STAFF REPORT: SEPTEMBER 11, 2024, MEETING
APPLICATION NUMBER: HDC2024-00477
ADDRESS: 1760 WABASH
HISTORIC DISTRICT: CORKTOWN
APPLICANT: TIMOTHY FLINTOFF, 4545 ARCHITECTURE
PROPERTY OWNER: SHARIF AFFAS, DETROIT DEVELOPING PROPERTIES, LLC
DATE OF PROVISIONALLY COMPLETE APPLICATION: AUGUST 19, 2024
DATE OF STAFF SITE VISIT: AUGUST 22, 2024

SCOPE: ERECT DWELLING AND CARRIAGE HOUSE

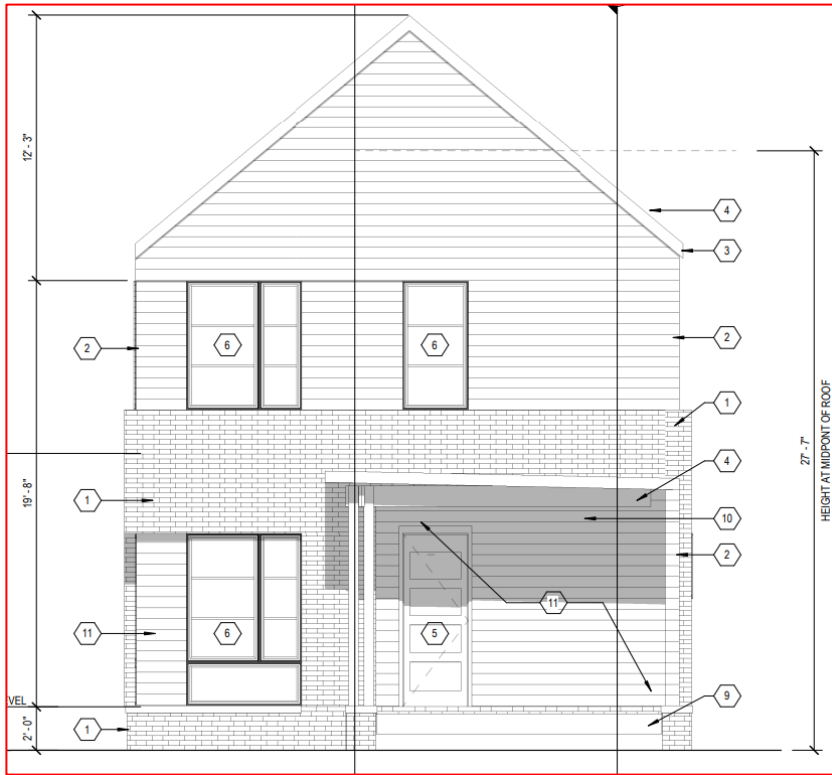
- **The proposed stone product is not appropriate. Stone is not mentioned in the Elements of Design and not consistent with historic residential buildings in Corktown. The particular specified product is further inappropriate in that it has a noticeably rough and unfinished-looking texture, and, due to its lack of the wider mortar joints used in traditional masonry, a monolithic appearance.**

- The architectural detail is largely compatible and appropriate (with a few exceptions discussed under “Issues,” below). This includes the front-facing gable roof and, importantly, the projecting, off-center porch. Such porches are common and important to the character of the Corktown Historic District. The smooth lap siding and stretcher bond brick are **is** also consistent with the character of the district.

- The blank (that is, not subdivided) casement windows specified fail to provide a sense of depth and texture that typically results from the use of subdivided windows. This is contrary to Element #3, Proportion of Openings within the Facades.

- **The proposed buildings deviate from their surrounding context and from the Elements of Design in two additional aspects that, in staff opinion, are relatively minor in scale and therefore do not detract from the overall appropriateness of the proposed buildings; they also provide an appropriate level of differentiation:**
 - **Neither shiplap siding nor unpainted wood siding are mentioned in the Elements of Design or found on historic buildings in Corktown. (The proposed use of stained cedar shiplap siding is limited to relatively small, sheltered areas on the first floor front façade only.)**
 - **The proposed buildings lack the projecting eaves typically found on both historic and compatible new buildings in the district.**

- **The stone veneer shall be replaced instead with an alternate product more closely resembling the texture of traditional bricks laid within mortar joints, subject to staff approval (wood lap siding would also be appropriate).**
- **If the mature ornamental tree in the back yard is removed, it shall be replaced with a new ornamental or shade tree elsewhere on the property.**
